197_PLN_302 EAST ELEVATION_SUMMARY OF CHANGES

LIST OF AMENDED DRAWINGS

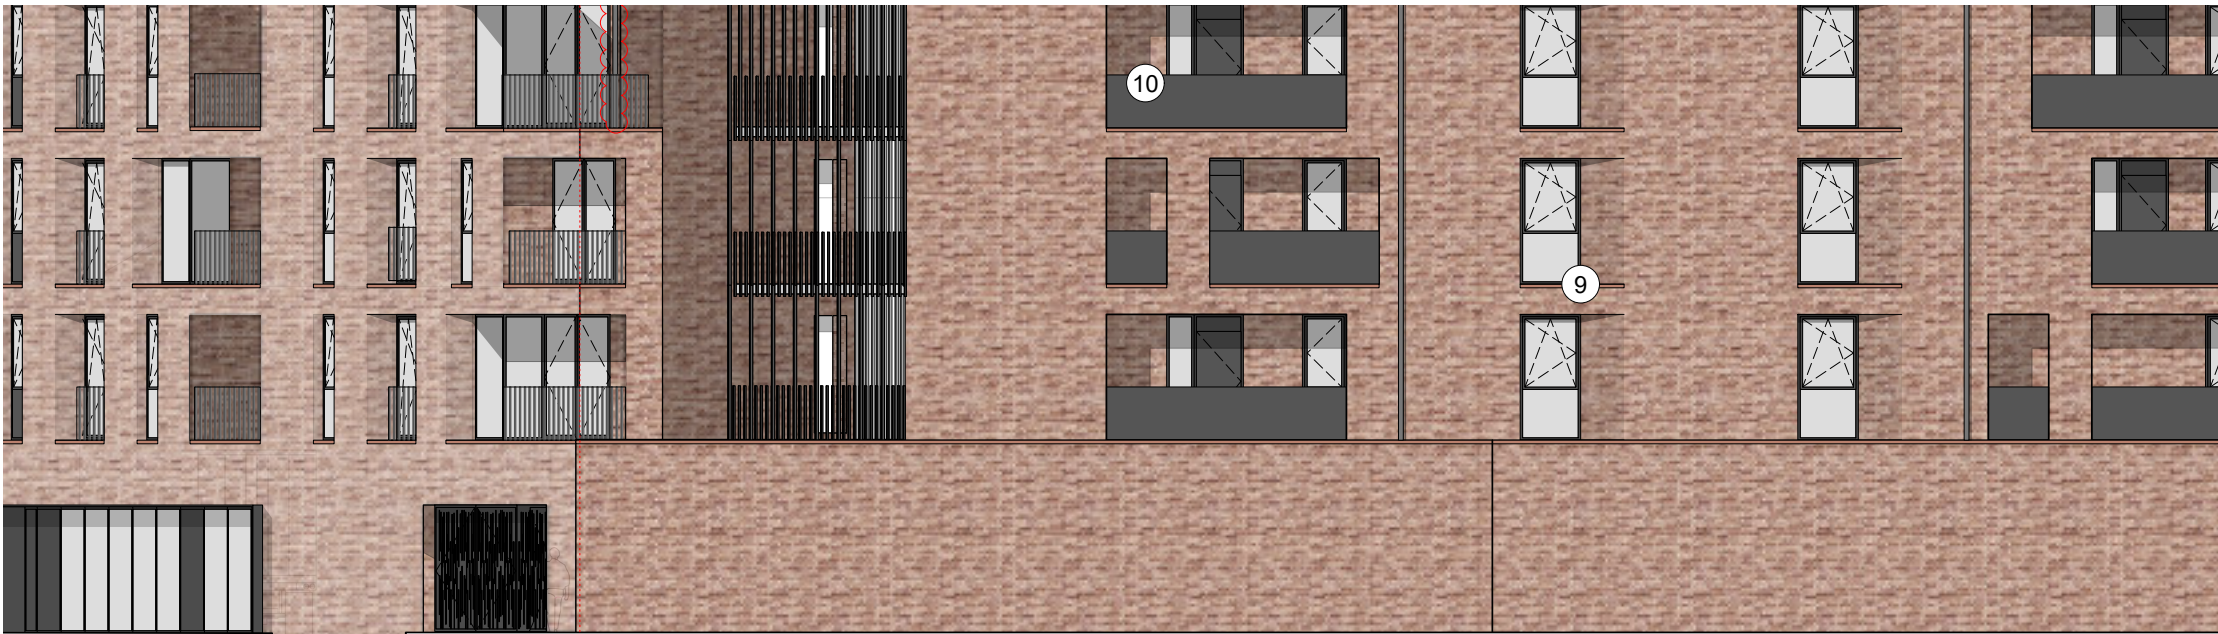
- At ground floor level, A new louvred door and a louvred grille are proposed to provide ventilation to the substation. These changes are described in more detail on page 3.

197_PLN_304 WEST ELEVATION COURTYARD_SUMMARY OF CHANGES

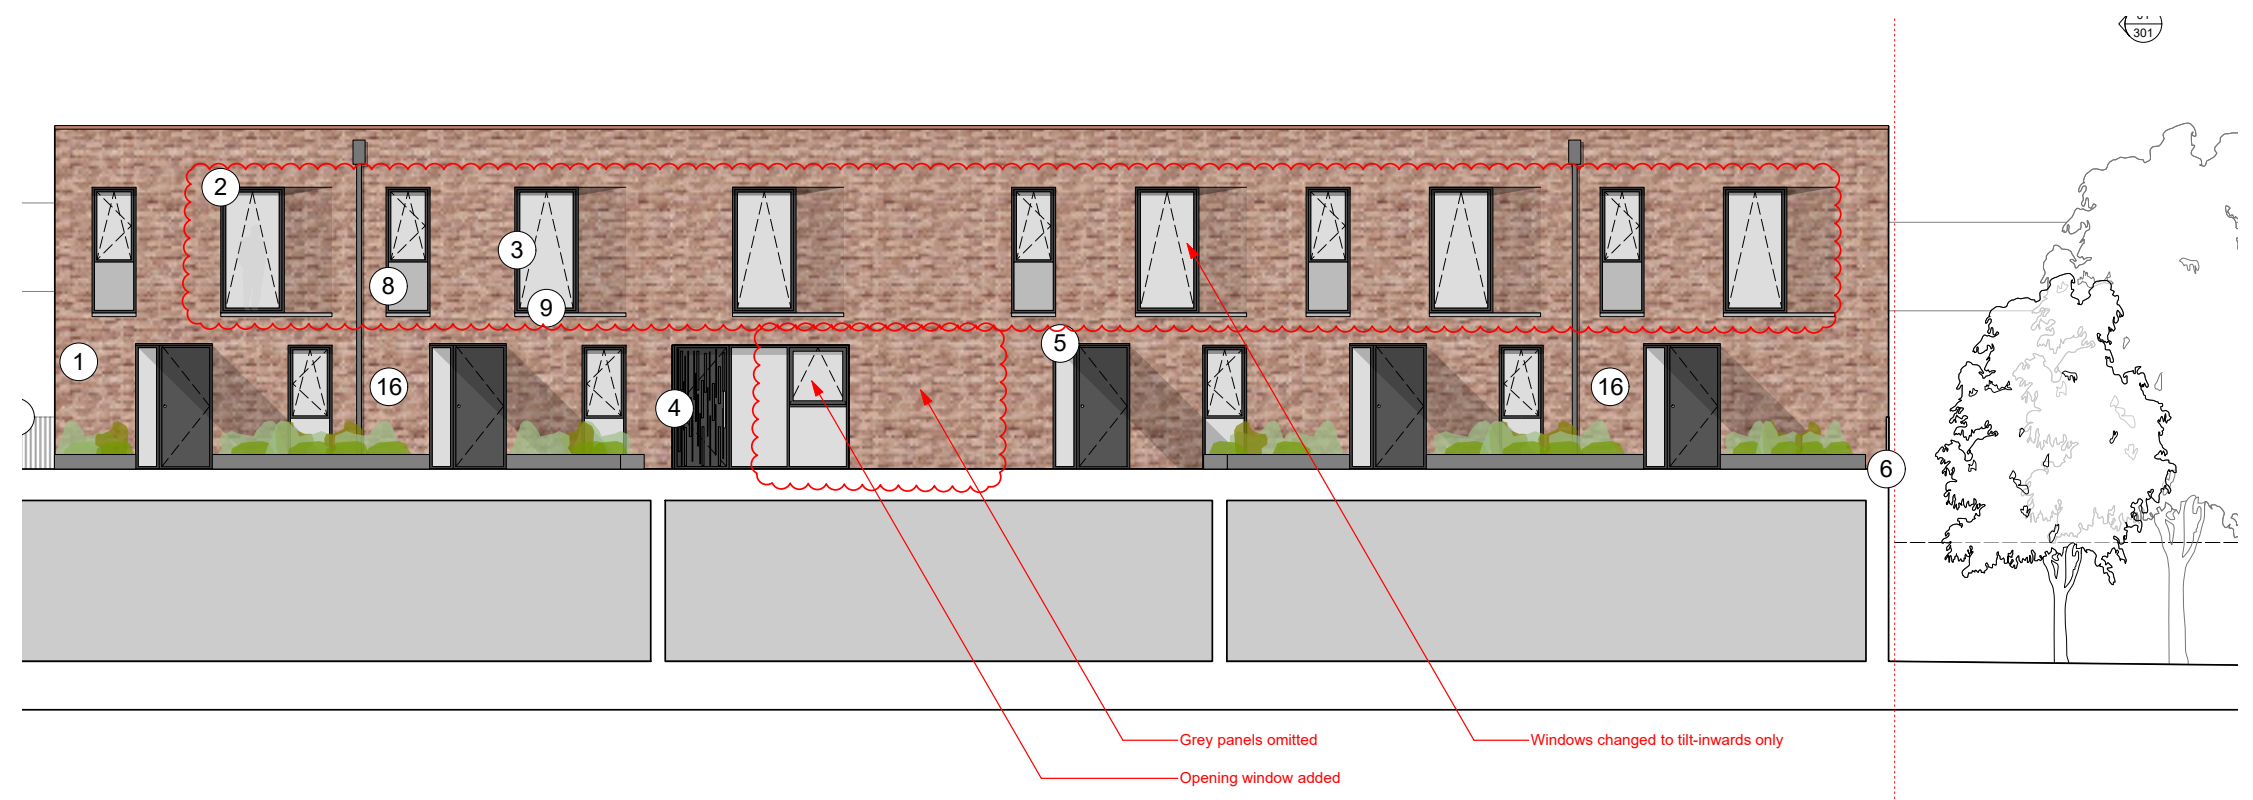
- At first floor (podium) level, changes are proposed to the courtyard facing curtain walling to the entrance lobby.

- A opening window has been added to meet the smoke ventilation requirements. This will be operated by AOV (automatic opening vent) equipment.

- Two solid grey panels are to be omitted. These are incompatible with the wall build-up required to the passenger lift behind. Brickwork is to replace the area formerly occupied by the grey panels.

- At second floor level, the operation of 6 no. Windows is proposed to change from tilt+turn to tilt-inwards only.
